APPLICATION NO.	FILING DATE	FIRST NAMED INVENTOR	ATTORNEY DOCKET NO.	CONFIRMATION NO.
10/779,502	02/13/2004	Andrew G. Gilicinski	08935-300001	1646
26161 7590 04/09/2007 FISH & RICHARDSON PC P.O. BOX 1022 MINNEAPOLIS, MN 55440-1022			EXAMINER ALEJANDRO, RAYMOND	
			ART UNIT	PAPER NUMBER
			1745	
SHORTENED STATUTORY PERIOD OF RESPONSE		MAIL DATE	DELIVERY MODE	
3 MONTHS		04/09/2007	PAPER

Office Action Summary

DETAILED ACTION

FIG. 1

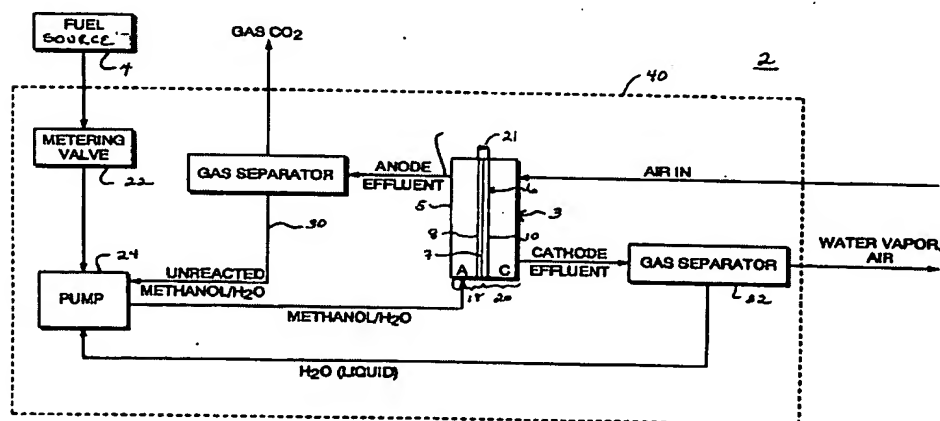
Figure 1 of Hirsch illustrates a fuel cell system 2 including a direct methanol fuel cell 3 (DMFC) (P0030); a methanol fuel delivery source 4 (P0030, 0032) and a pump 24 (the gas mover) assisting in the circulation of fuel and positioned between the fuel cell 3 and the fuel delivery source 4 (See FIGURE 1 & P0032-0033).

Fuel delivery source 4 is designed to enclose/hold and to supply the methanol (P0030, 0032). *Thus, it comprises a housing.* Figure 1 depicts its outlet (See FIGURE 1); and the pump 24 (the gas mover) is positioned between the fuel cell 3 and the fuel delivery source 4 (See FIGURE 1 & P0032-0033).

Disclosed therein is that un-reacted methanol and water is separated from carbon dioxide in separator 30 and re-circulated to the pump 24 (P0033). *Thus, in this case, gas separator 30 separating un-reacted methanol and water from carbon dioxide is taken to also represent a fuel source (because it is supplying un-reacted methanol), and in combination with the recirculation loop provide the necessary arrangement to have the pump 24 between the fuel source inlet and the fuel cell after a first recirculation loop cycle is completed.*

In the absence of a specific structural description of a diffusion tube, it is contended that the pipe supplying methanol/H₂O to the fuel cell (See FIGURE 1) can be considered to be a diffusion/distribution tube.

Metering valve 22 is placed between the fuel cell 3 and the fuel delivery source 4 (See FIGURE 1).
